CHG TO: 80 149			
THIRD ANGLE PROJECTION	SIZE	STROKE	TYPE
DRAWN C.W. GOWDY	DATE 02SEP09	15.00	ALL HOS
CHECKED B. BENNITT	DATE 18SEP09	NAME OF PART OUTLINE - 15.00 VVCP CYLINDER	
APPROVED B. BENNITT	DATE 18SEP09	SIZE C	FEDERAL SUPPLY CODE ---
		DWG NO. HIHO1551	REV. 01
		SCALE 1:12	WT. SHEET 1 OF 1

19.16 (5.0" STR)  
 18.66 (6.0" STR)  $\Delta$   
 18.16 (7.0" STR)  
 REQUIRED FOR  
 REMOVAL OF  
 PISTON & ROD

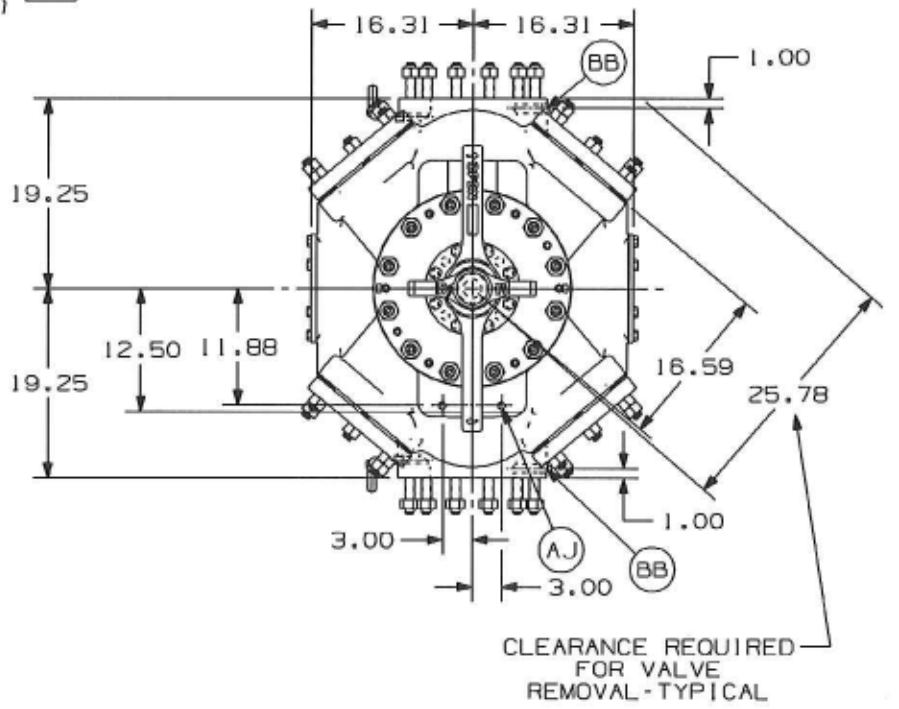
REVISIONS				
ZONE	REV	DESCRIPTION	DATE	APPROVED
	01	18.65 WAS 25.20; 18.16 WAS 24.70; ADDED 19.16(5.0" STR); ECN-PPT11554 KMD	17JUN11	BAB
